RESPONSE TO COMMENTS

Title: UAV-enabled reconnaissance and trajectory modeling of a co-seismic rockfall in Lefkada

Journal: NHESS

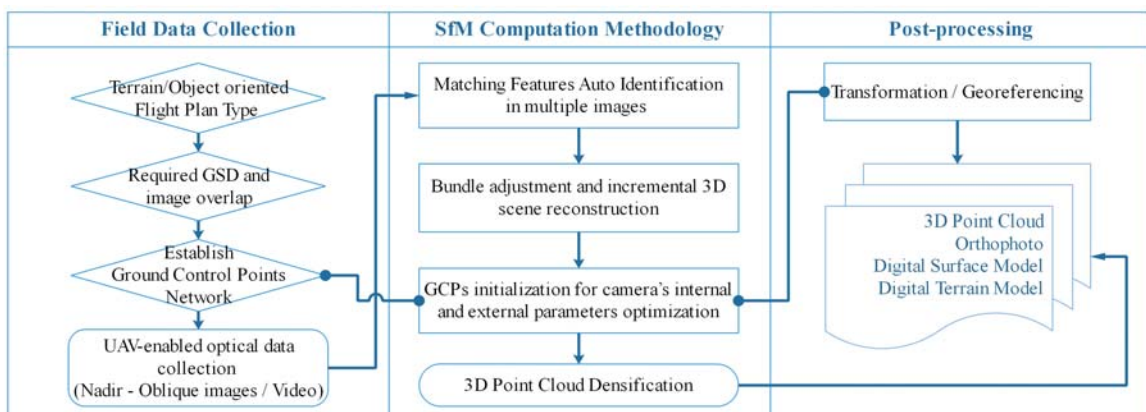
From the manuscript is not clear how the images or videos have been processed nor is the accuracy of the DSM discussed in detail.

Response: We follow the typical procedures for Structure-from-Motion as laid out in the following Figure, which will be added in the manuscript. These include the following steps:

In addition, the accuracy of the model has been examined by using portions of the ground control points and developing DEM of differencing between different models, an investigation that is described in our paper by Manousakis et al. (2016). Finally, we have also made a comparison, and we plan to add that in our paper, of the DEM

developed by the UAV against the satellite-based DEM that is part of the Greek cadastre. The two surfaces were found to be very similar.

Figure 11

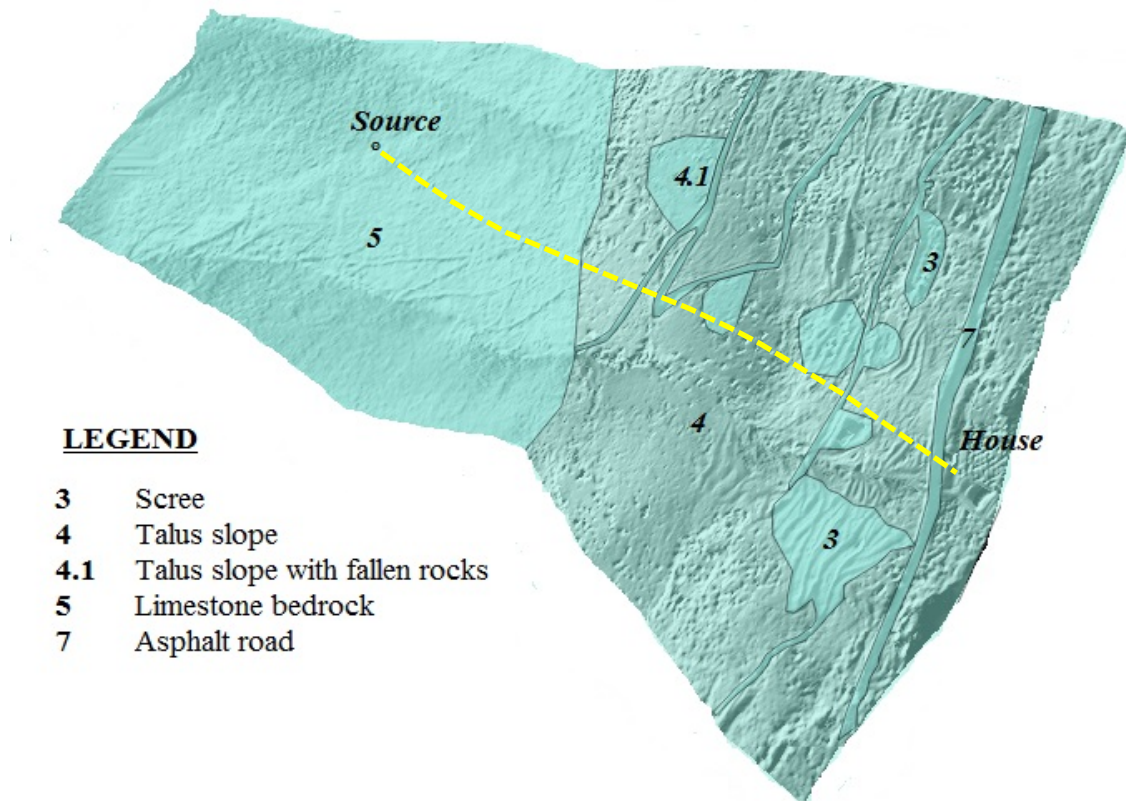
Figure 11 / Figure 13 it will be nice add the real path of rockfall for comparison with the results from simulations.

Response: We added the actual path on the Figures.

Figure 13

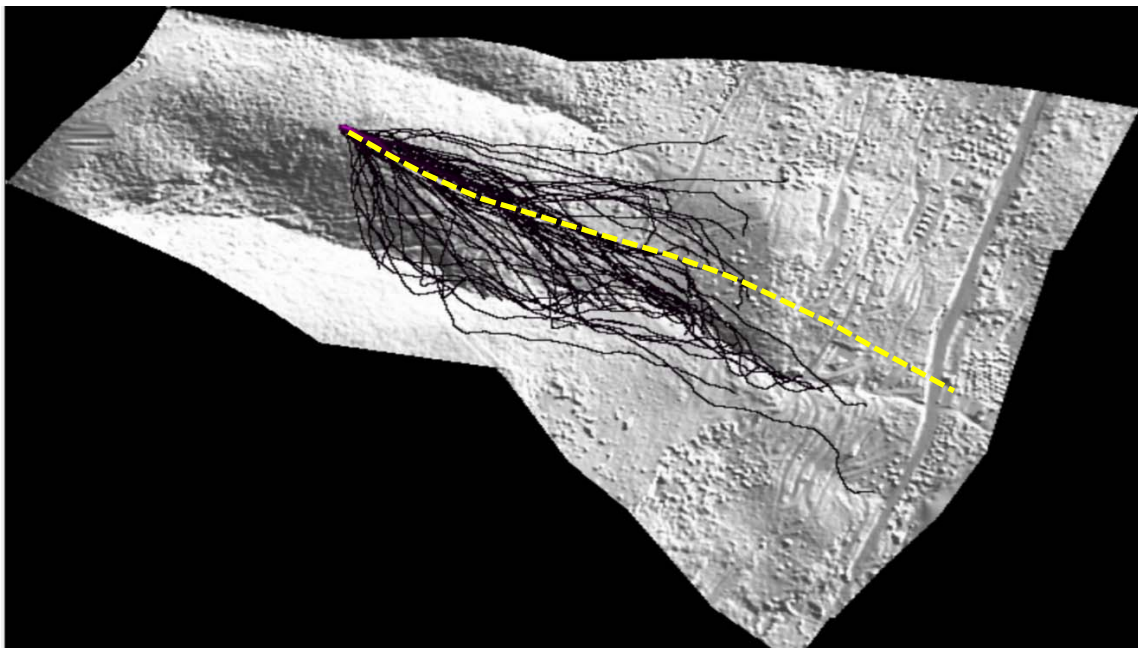
It is interesting to note that a very strong dispersion starts right at the source. Do you have a clear explanation for this? Also, the vegetation might play an important role during the rolling phase. Is the rolling phase more realistic in these simulations compared to the one of Rocfall? How many simulations did you perform? Could you

perform more simulations? Finally, it seems that the DSM includes a lot of vegetation but you also model roughness by MOH although you say no vegetation was considered in the analysis (line 323-327). This is kind of contradicting and needs to be clarified

It is true that there is a strong dispersion at the source. The reason for this dispersion is the topography effect of the area of detachment, as discussed in par. 6.3.

We performed a significant number of simulations (with a range of restitution parameters. The scope was to run the 3D analysis according to the restitution parameters and soil types suggested by Rockyfor3D and discuss the results. The total number of simulated falling rocks (total nr. of simulations) was 120 for each analysis.

As explain in the response of a previous comment, the vegetation was removed from the DSM. The roughness, which was considered in the 3D analysis, refers to the slope terrain (not the vegetation) and is modelled according to the suggested method of Rockyfor3D using coefficients rg10, rg20, rg70 (see previous comment).
